SF Rush the Rock

Field Service Bulletin

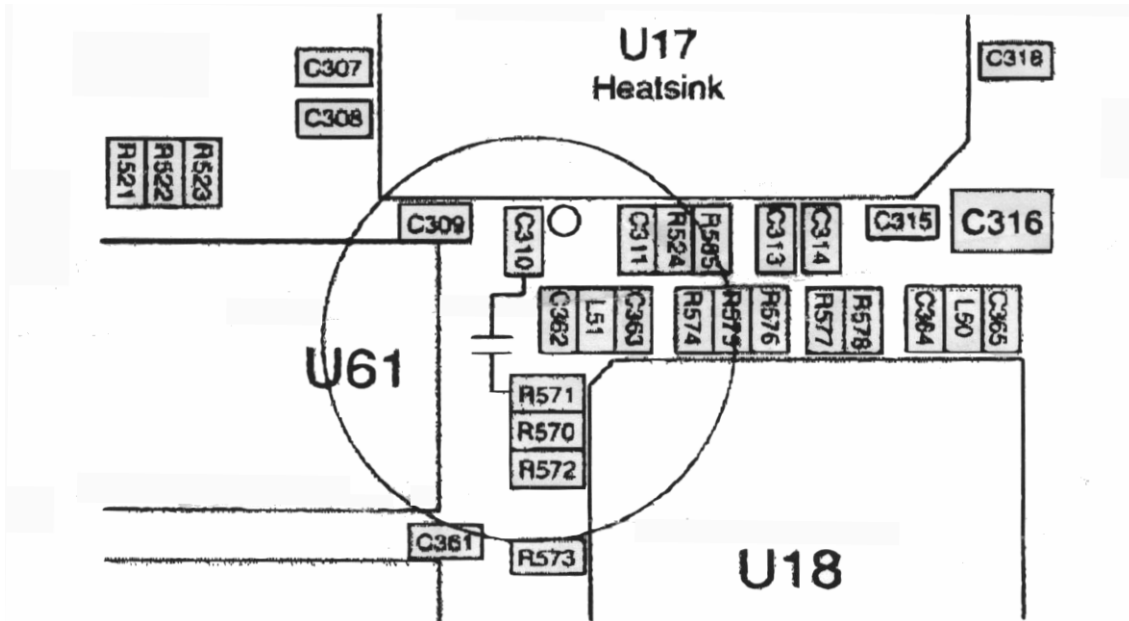
It has come to our attention that some **SF Rush the Rock** CPU boards (PN. #'s A-21937) may exhibit a reset problem. Symptoms are: the game freezes then re-boots during game play. To fix this timing error, solder a 10pF 10% axial capacitor (part # 5048-12503-00) from the load side of R571 to the ground side of C310. See below for an exploded view of the exact location on the board of the added capacitor.
